Coastal Works Review

Cleveland Dilbert – Saltwater Pond Marina – Excavation offshore to create a marine boat channel. Block: 95C Parcel: 39

February 20, 2014

Authored by: Technical Review Committee - Department of Environment

FIGURE 3: SOUTH WEST COAST DRAINAGE BASIN (SOURCE: DOE/LIS, 2013)

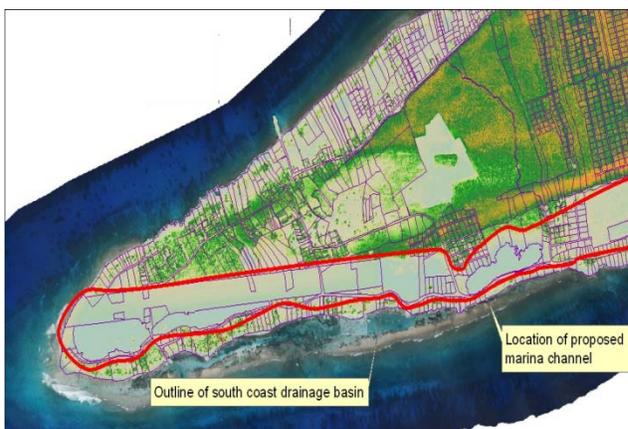
- The coastline immediately in front of Saltwater Pond is a storm ridge, comprised predominantly of sand, rocks and rubble. Breaching this protective storm ridge with a 100ft wide channel will **expose both coastal and inland properties (potentially as far as the airport through the westerly ponds drainage basin connections) to increased flood risk and storm damage** from the sea. The predicted extent of the potential exposure to wave overtopping, flooding and increased risk of wave and flood induced storm damage to surrounding properties, including the applicant's hotel and all properties to the west within the drainage basin depicted in Fig 3, has not addressed in the applicant's submission.

FIGURE 5: MARINE RESOURCES HEALTH INDEX SHOWING THE SOUTH WEST CAYMAN BRAC AS HEALTHIEST REEFS. (DOE)

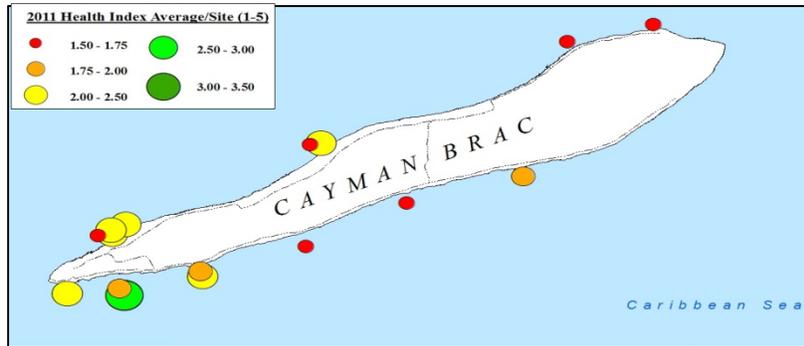
- The pond acts as a water catchment area for the surrounding wetlands. During the rainy season this water collects in the pond and the sediment and nutrients are able to settle out. Excavating the pond and directly opening it to the sea will result in an **increase loading of detrimental nutrients and sediment to the marine environment on a permanent basis**. This is of particular concern due to the prevailing westerly currents in the vicinity of the healthiest reefs and popular dive sites, which depend on clear, nutrient-free water, Figure 4 and 5. Figure 5 which is derived from the DoE's long-term coral reef monitoring programme clearly shows that the location of the healthiest coral reef on the Brac is immediately to the west of the proposed channel and therefore in the direct line of influence of the outflow of the channel.
